State of Alaska  
Department of Fish and Game  
Sportfish Division

Nomination Form  
Anadromous Waters Catalog

Name of Water Body \*Tiny Creek

Nomination # 24-844

Map #1

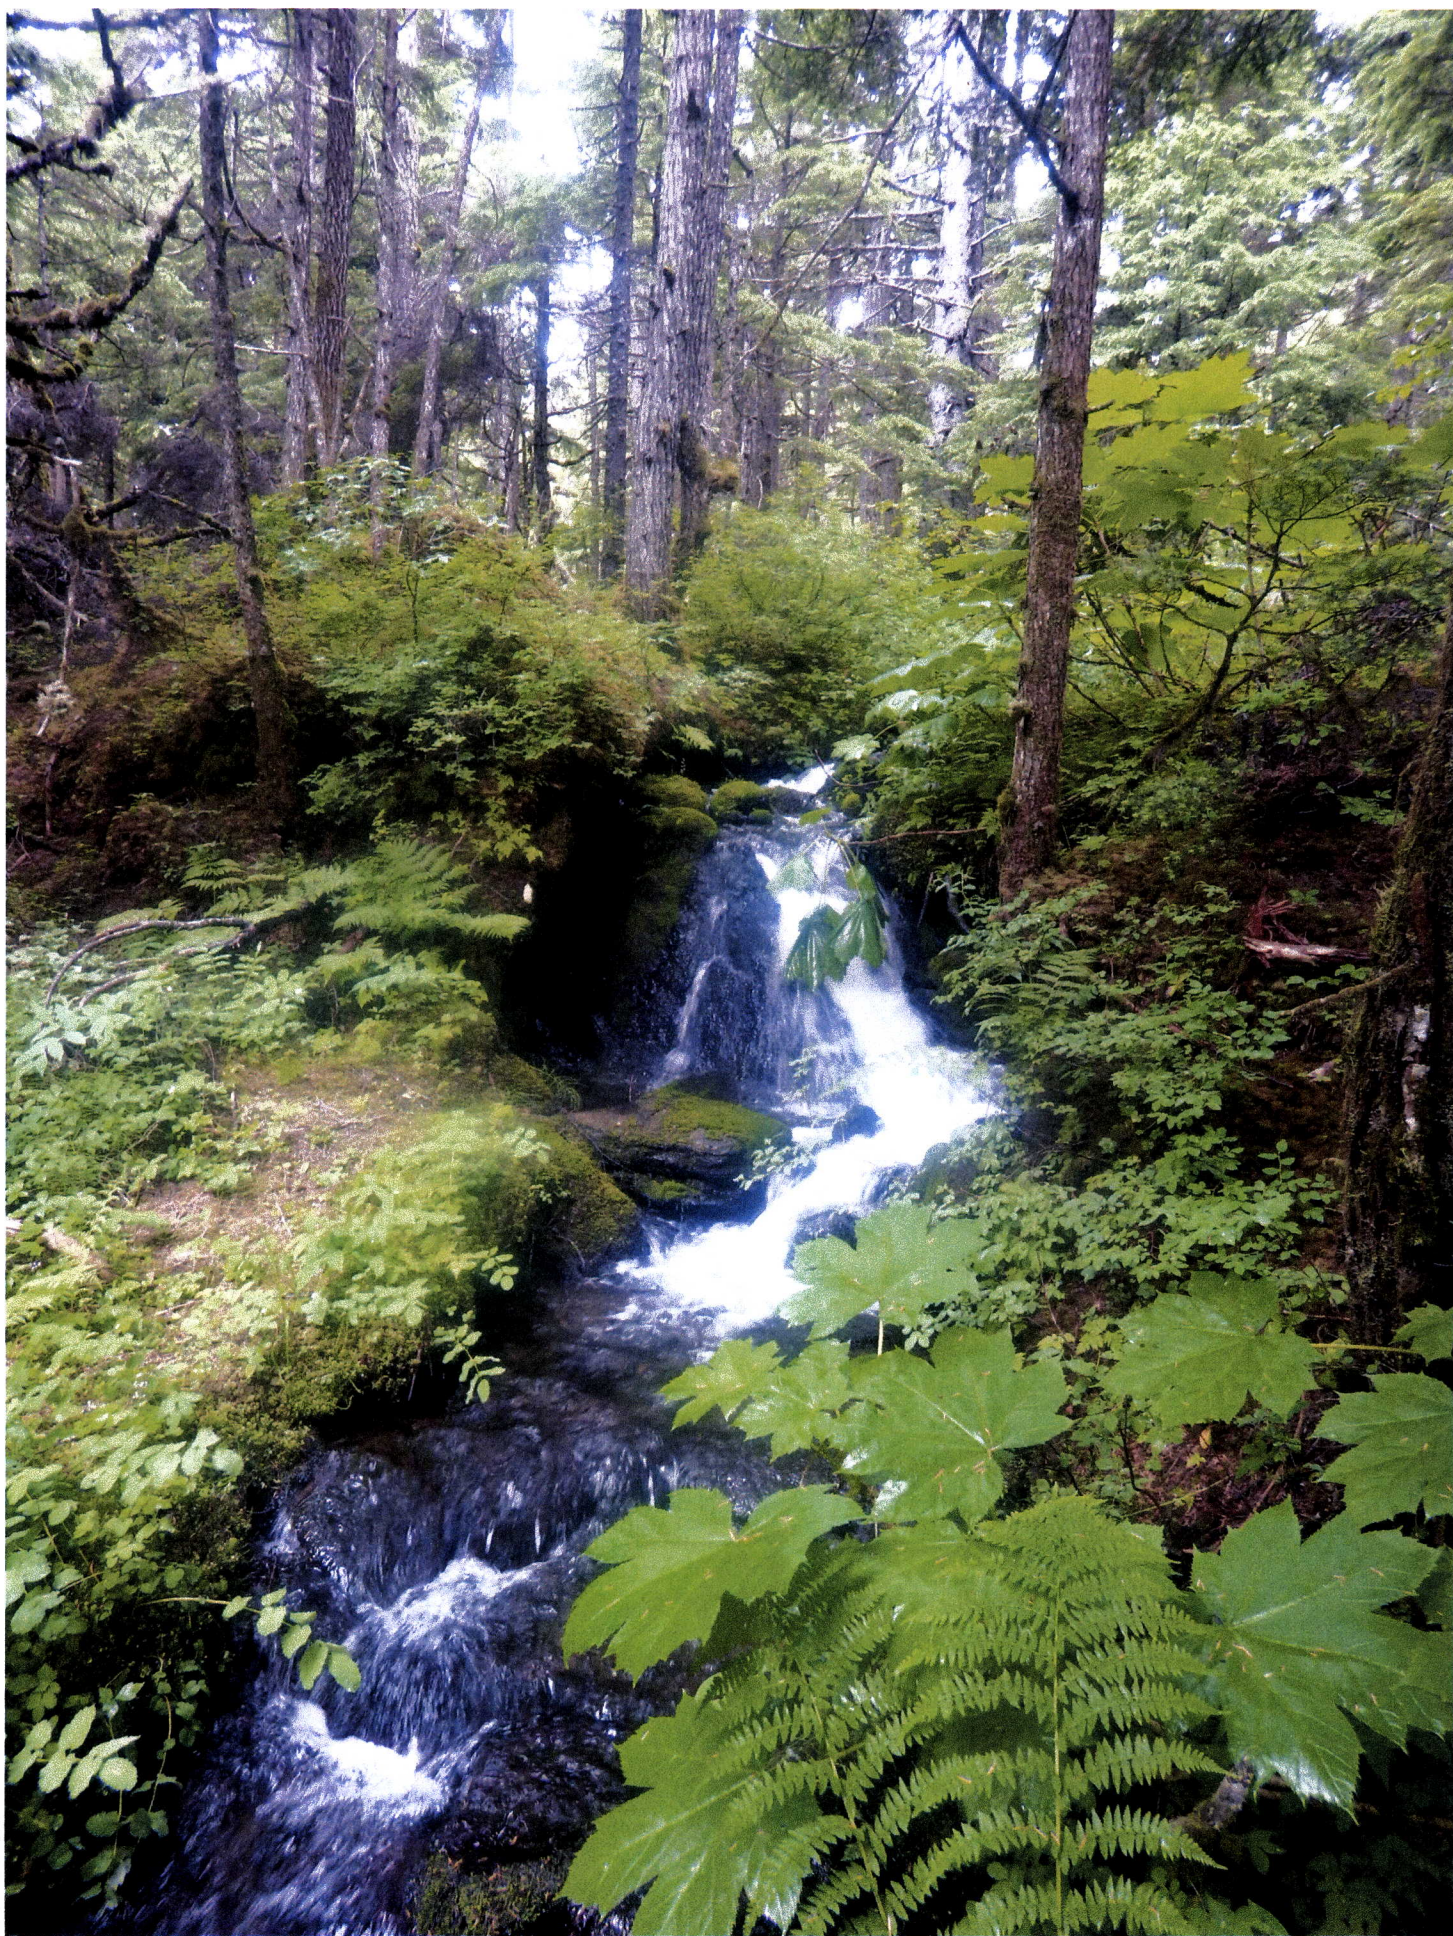
~EXTEND existing AWC Stream #247-60-10250-2007-3030 **"Tiny Creek"** with COHO salmon REARING.

~ADD new barrier above new upper extent of existing AWC Stream #247-60-10250-2007-3030 **"Tiny Creek"**.

-Please update using most recent .GDB with line, point, lake, polygon and barrier features located in O:\DSF\5\AWC\Draft2025\GIS\DATA\AWC\_2025update\_WORKINGv1\_day-month-yr.gdb

Map #2

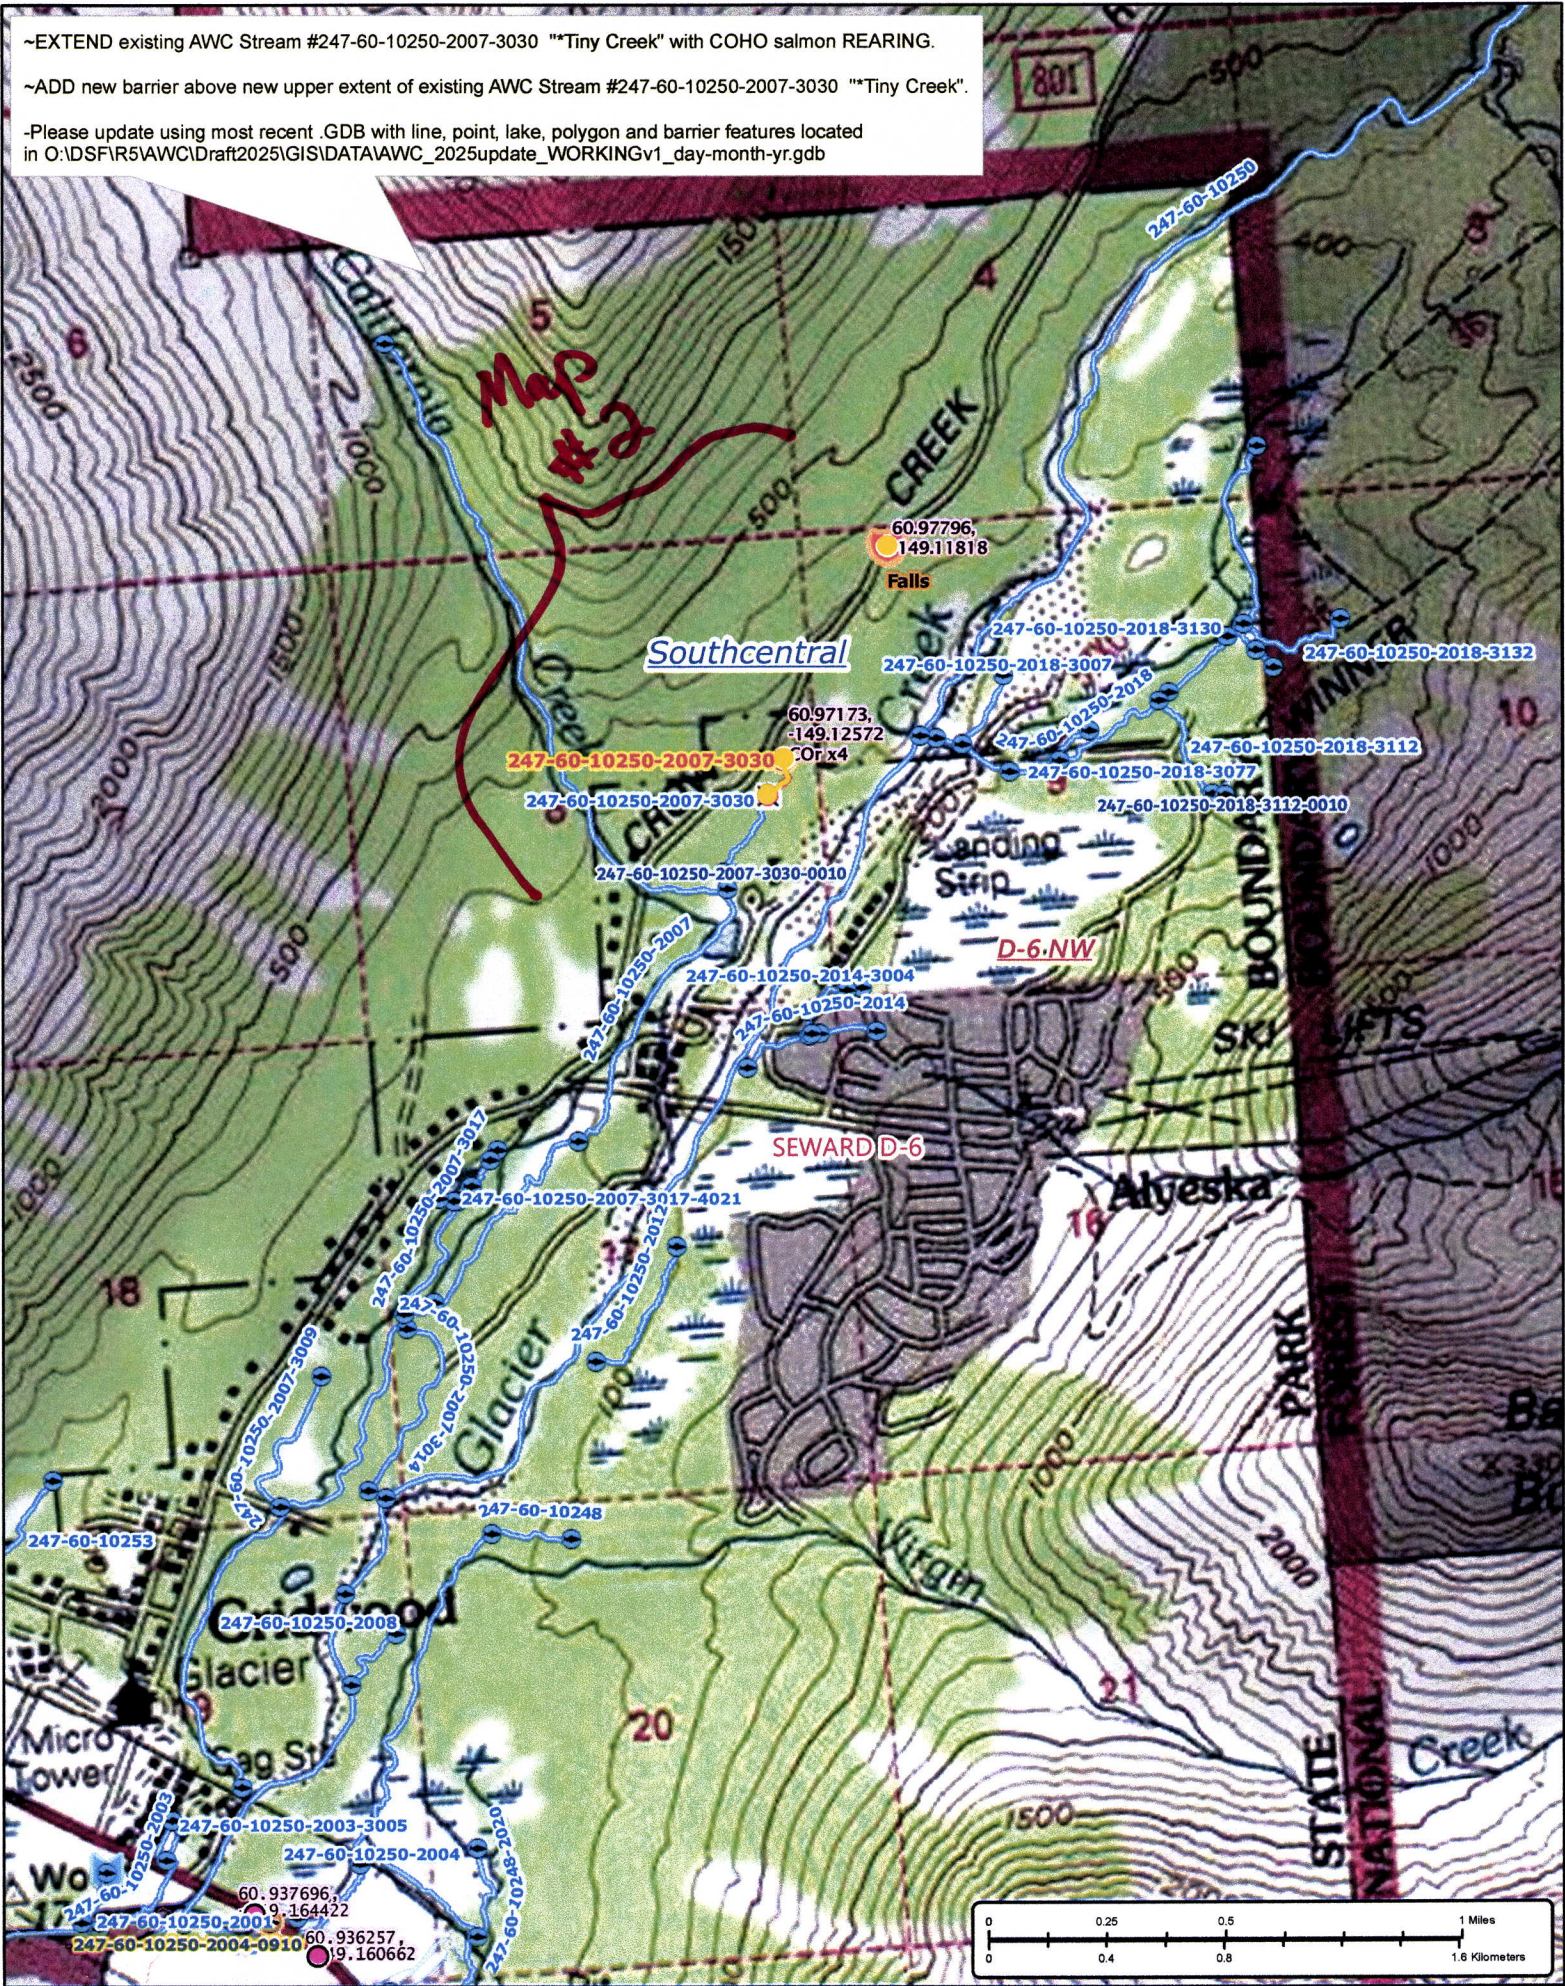
~EXTEND existing AWC Stream #247-60-10250-2007-3030 "Tiny Creek" with COHO salmon REARING.

~ADD new barrier above new upper extent of existing AWC Stream #247-60-10250-2007-3030 "Tiny Creek".

Add  
New Barrier  
#247-60-10250-2007-3030

Cor new  
UPPER  
60.97173,  
-149.12572  
CORX4

DELETE  
delete  
old  
upper

-Please update using most recent .GDB with line, point, lake, polygon and barrier features located in O:\DSF\15\AWC\Draft2025\GIS\DATA\AWC\_2025update\_WORKINGv1\_day-month-yr.gdb
